Amendments to the Drawings:

REMARKS

Fig. 1

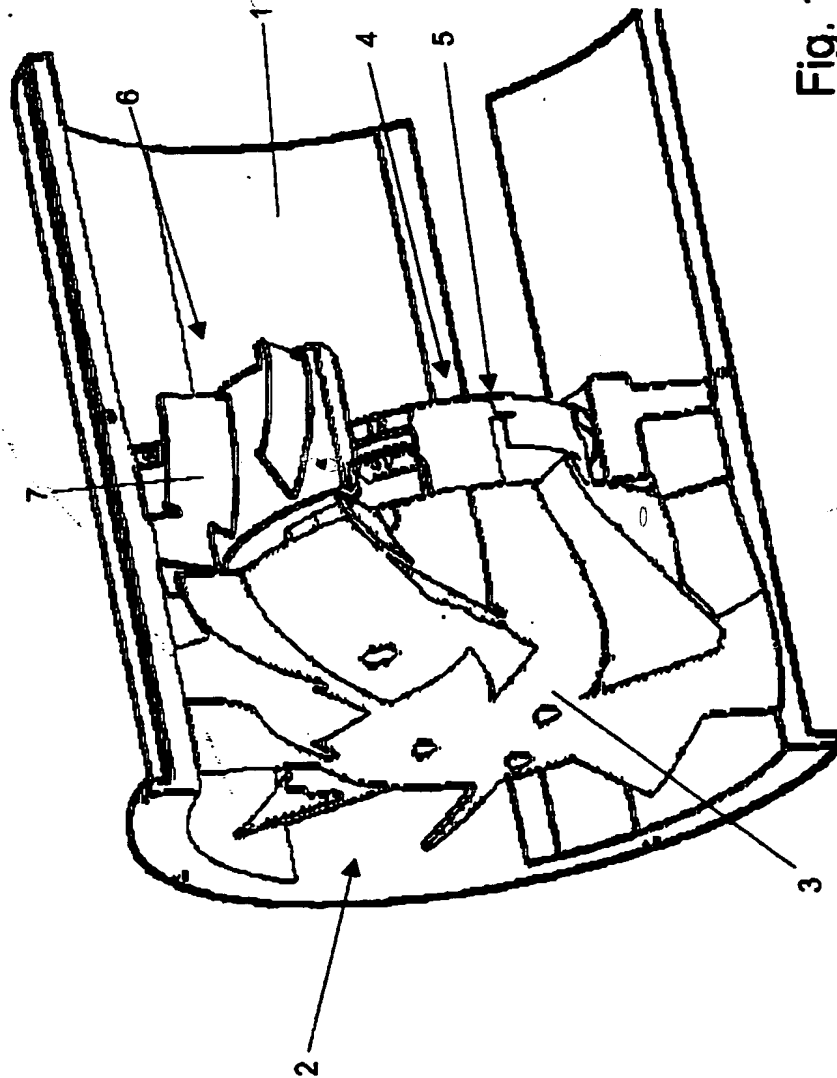
The specific changes which have been made to the Figures are to rotate Figures 1-3 clockwise 90°, to remove the solid black region from Figure 2, to add element 106 to Figure 4, and to present new formal drawings with smooth lines.

ROTATED FIGURE
CLOCKWISE 90°

Fig. 2

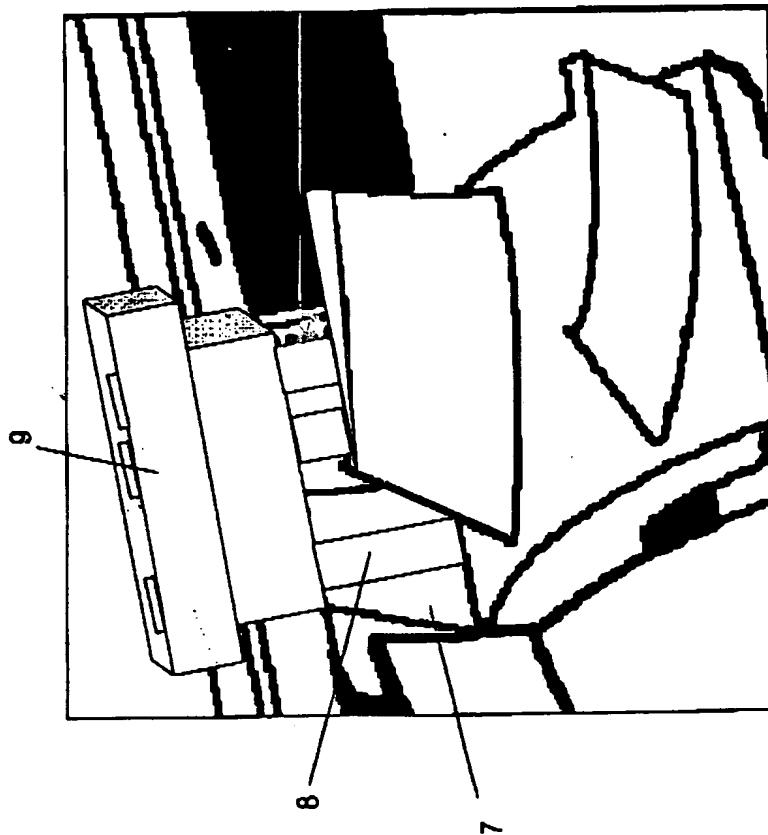
ROTATED FIGURE
CLOCKWISE 90°
AND REPLACED SOLID
BLACK AREAS WITH
DASHED LINES

Fig. 3

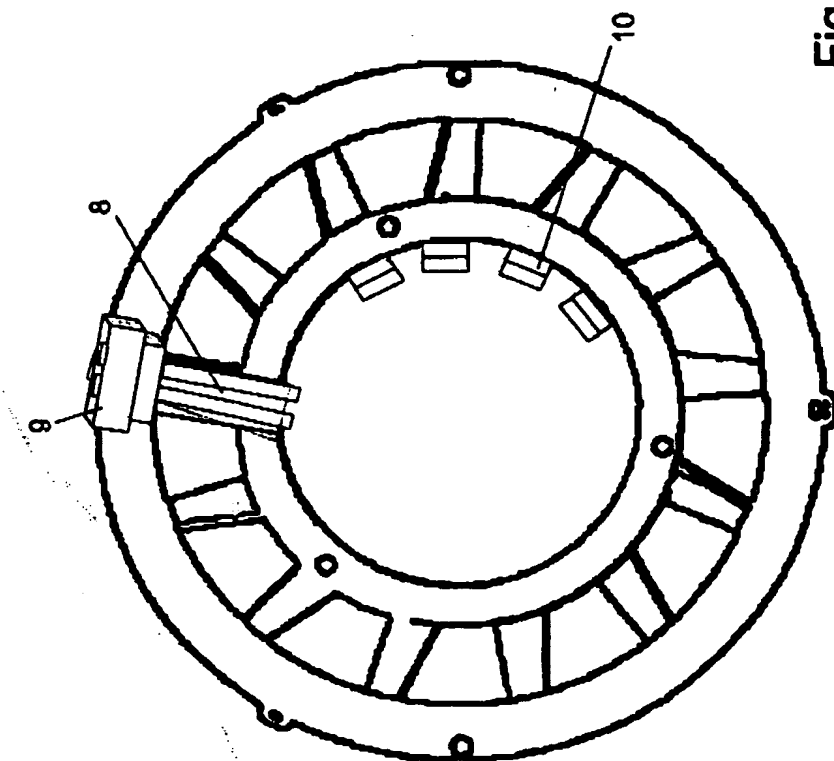
ROTATED FIGURE
CLOCKWISE 90°
